**WORK PLANS**

April 19, 1991

## PHASE II RFI

### PHASE II WORK PLAN DEFICIENCY NO. 1:

FIGURE 3-3  
 POTENTIOMETRIC ELEVATIONS OF  
 SELECTED WELLS  
 COMPLETED IN THE  
 SHALLOW VALLEY FILL AQUIFER  
 ARTESIA, NEW MEXICO

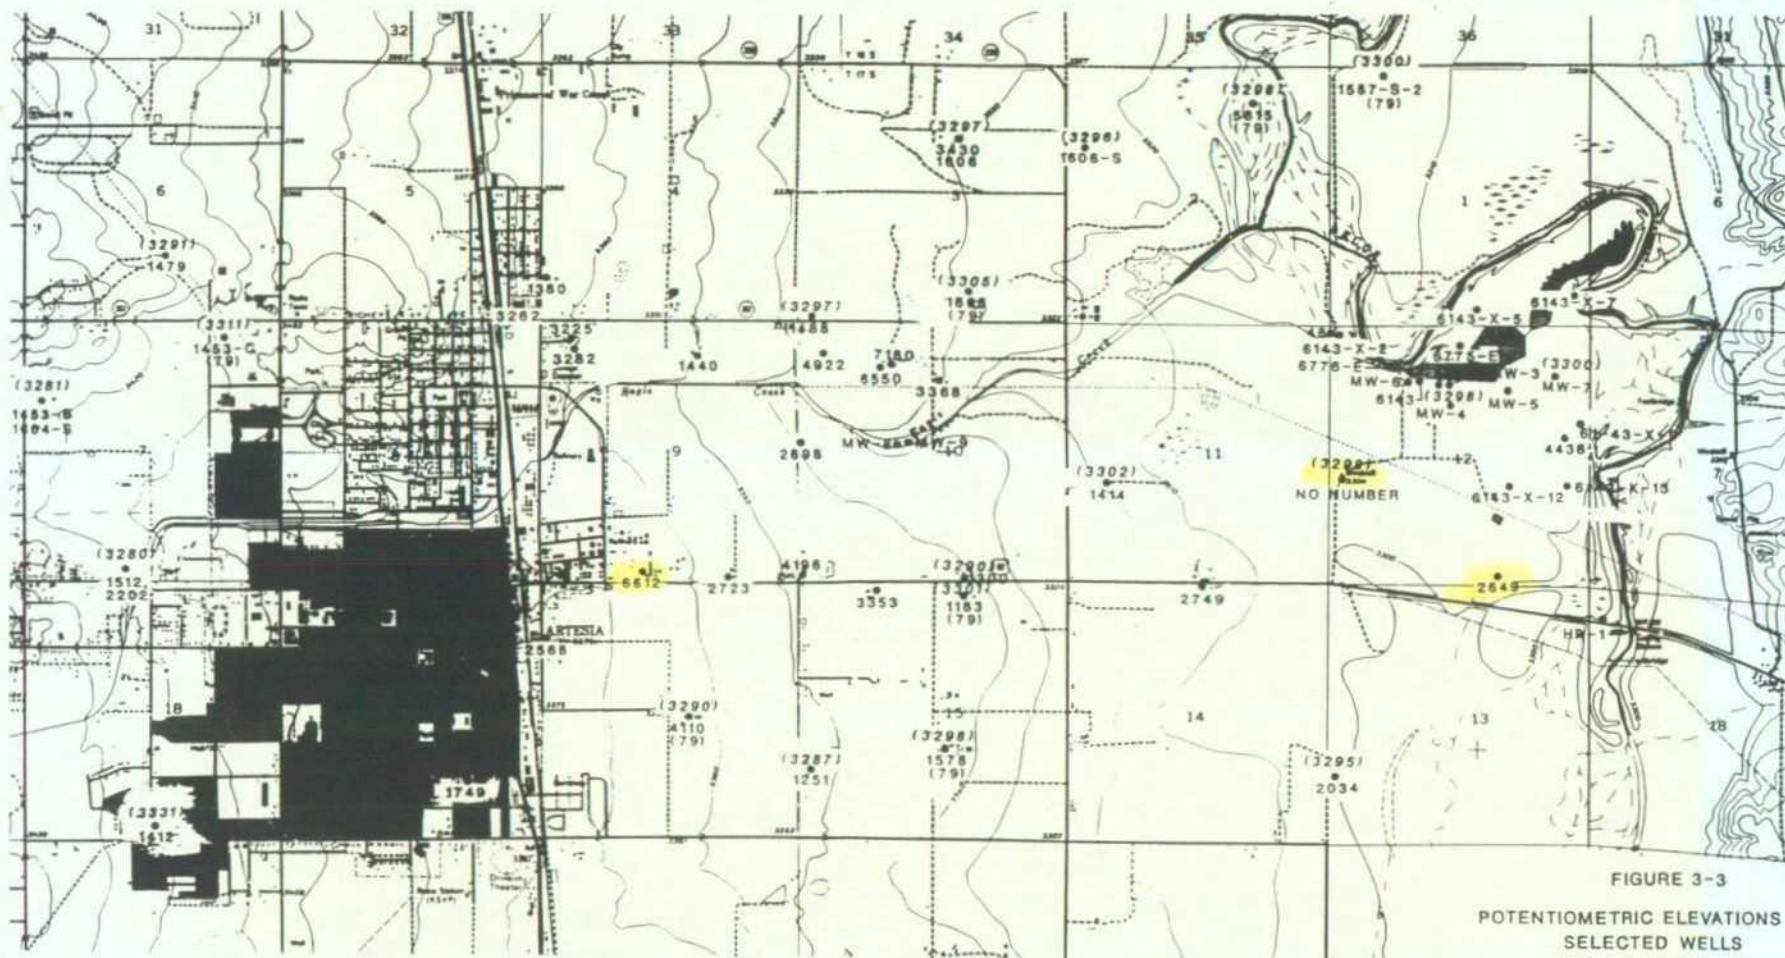
Navajo needs to indicate all wells/windmills (this includes production groundwater wells) within two (2) miles of the evaporation ponds and the Three-Mile Ditch; and within a one (1) mile radius of the refinery. Some of these wells need to be sampled to assure no contamination of any usable deep or shallow aquifers.

Navajo has compiled a list of the water wells in the area requested. Table 3-1 lists the wells completed in the Shallow Valley Fill Aquifer. Table 3-2 lists the wells completed in the Deep Artesia Aquifer. Correspondingly, Figure 3-3 illustrates the locations of the wells listed in Table 3-1 for the Shallow Valley Fill Aquifer and Figure 3-4 illustrates the locations of the wells listed in Table 3-2 for the Deep Artesia Aquifer.

Navajo has highlighted on Figures 3-3 and 3-4 those wells that U. S. EPA may want to select to be sampled to assure that no contamination of usable water is occurring in either aquifer. Navajo intends that these well analyses be a one time event barring the discovery of any contamination. Navajo suggests that SEO (State Engineer's Office) well number 2649 and the windmill in the evaporation ponds area and SEP well number 6612 in the refinery area be sampled as representative of the Shallow Valley Fill Aquifer. Navajo also suggests that SEO well numbers 602 and 768 be sampled as representative of the Deep Artesian Aquifer in the refinery area. There doesn't appear to be any good well candidates in the Deep Artesian Aquifer in the area of the ponds, perhaps SEO number 895 could be sampled, as it is the closest Deep Artesian well to the ponds.
